Addendum No. 1

PROJECT:	Addition & Interior Renovations for the Marlboro Free Library
ARCHITECT PROJECT N°:	23•46•06
DATE:	6 June 2025

Addition & Interior Renovations for the MARLBORO FREE LIBRARY

SK2-C102-1

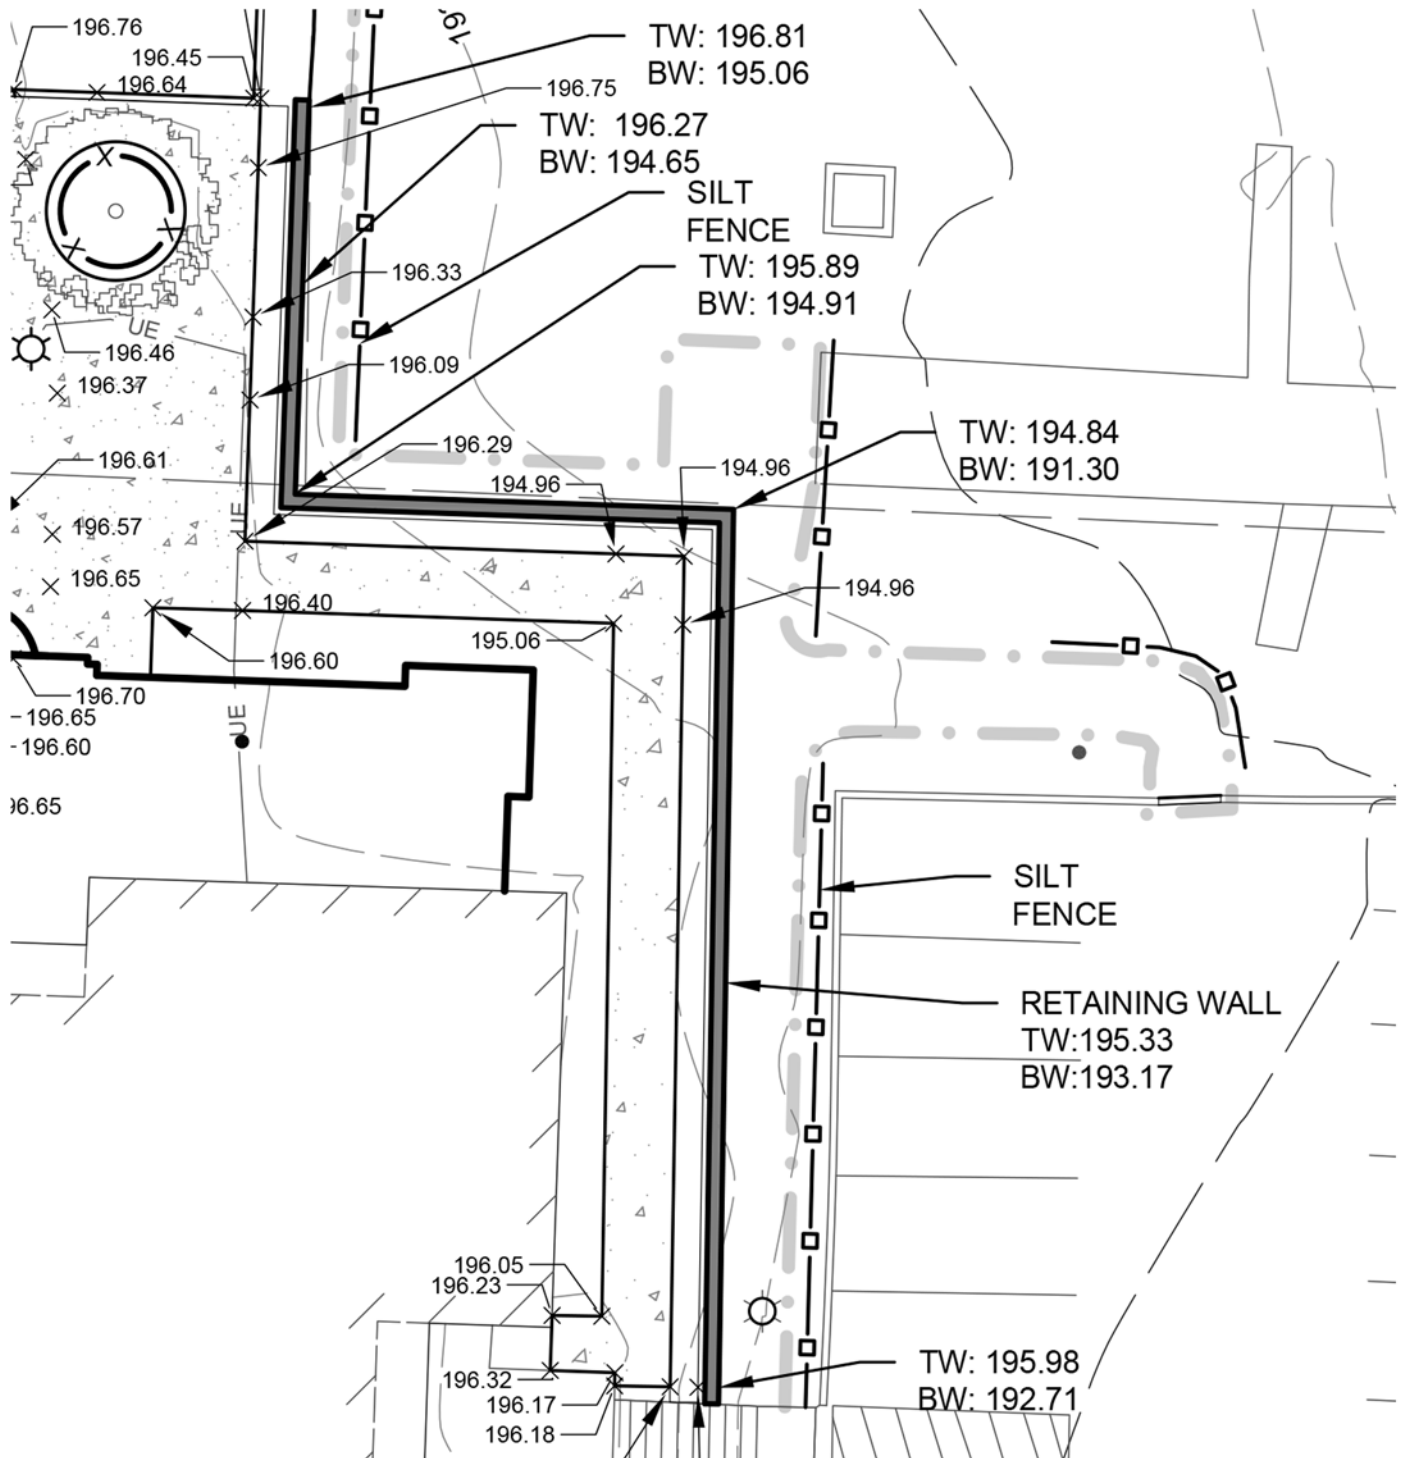
Add attached sketch SK2-C102-1 for proposed retaining wall elevations.

SK2-C301-1

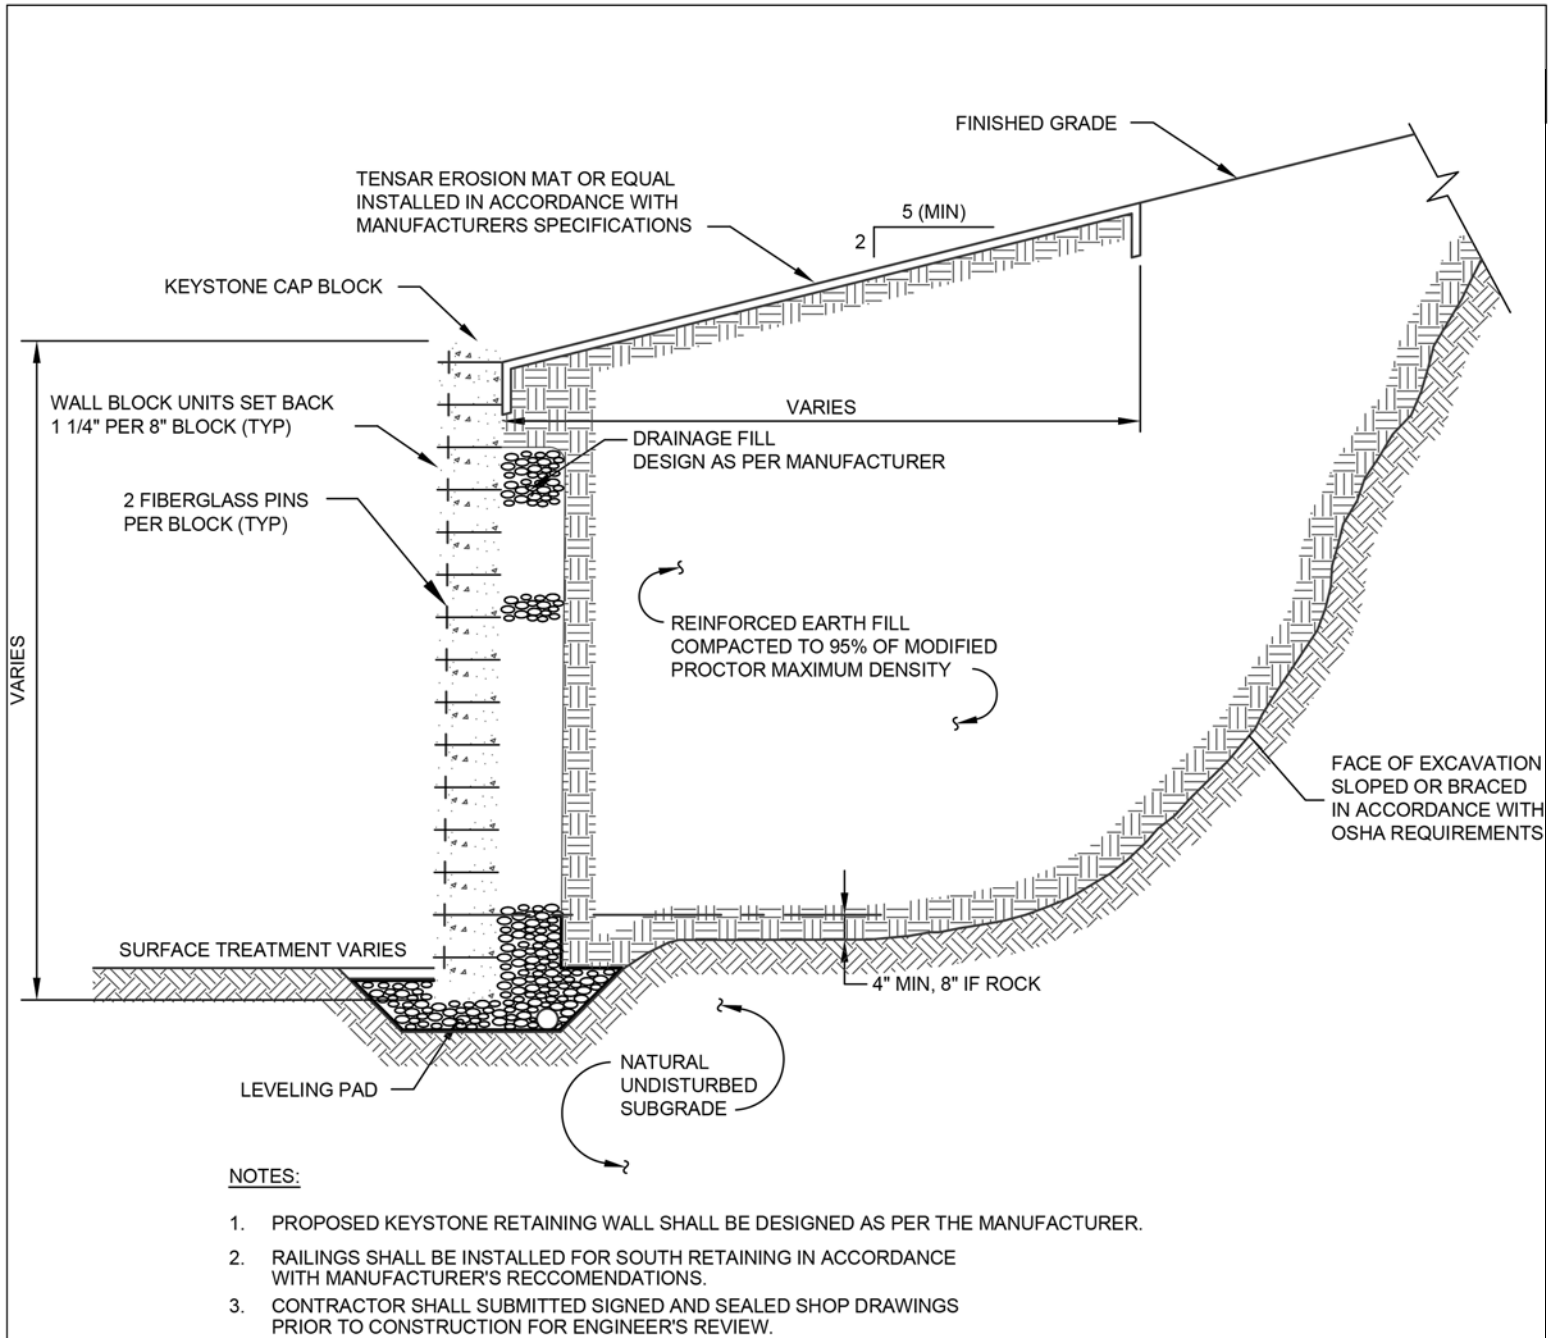
Add attached sketch SK2-C301-1 for Typical Keystone Retaining Wall detail.

TYPICAL KEYSTONE RETAINING WALL

SK2-ER101-1

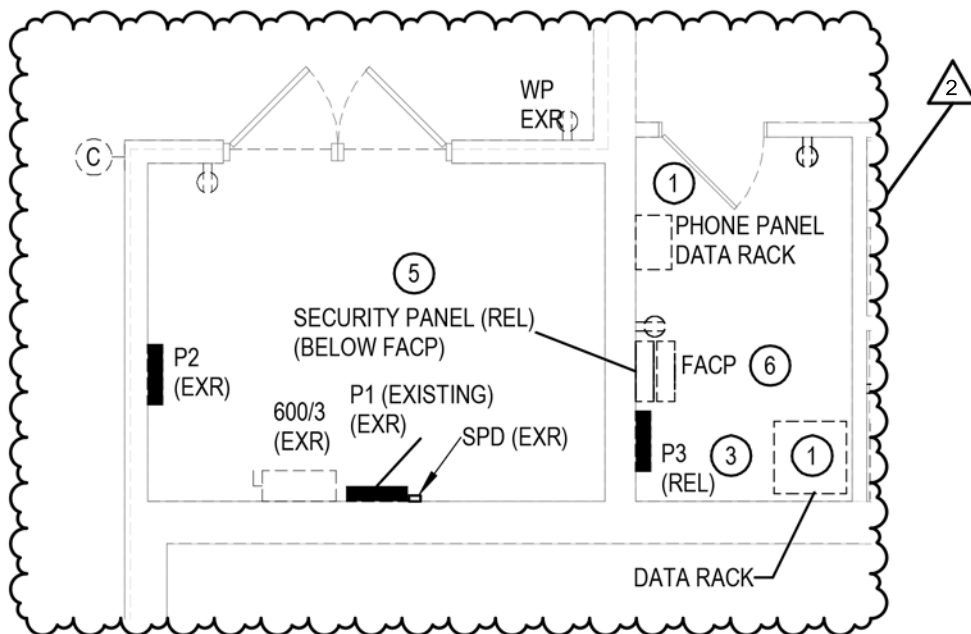
Add attached SK2-ER101-1 for Note Tag 6 added to Room #111; New General Note #3, and revisions to Keyed Note 6.

- 1 PRESERVE AND RELOCATE PHONE PANEL, SECURITY PANEL, DATA RACK, AND ASSOCIATED COMPONENTS.
- 3 RELOCATE PANELBOARD AND EXISTING CIRCUITS TO REMAIN FROM HERE TO NEW LOCATION OF PANEL.
- 5 RELOCATE SECURITY SYSTEM AND EXTEND EXISTING WIRING TO NEW LOCATION. COORDINATE WITH OWNER'S VENDOR.
- 6 PRESERVE AND RELOCATE PHONE PANEL, SECURITY PANEL, PANEL P3, AND ASSOCIATED COMPONENTS.
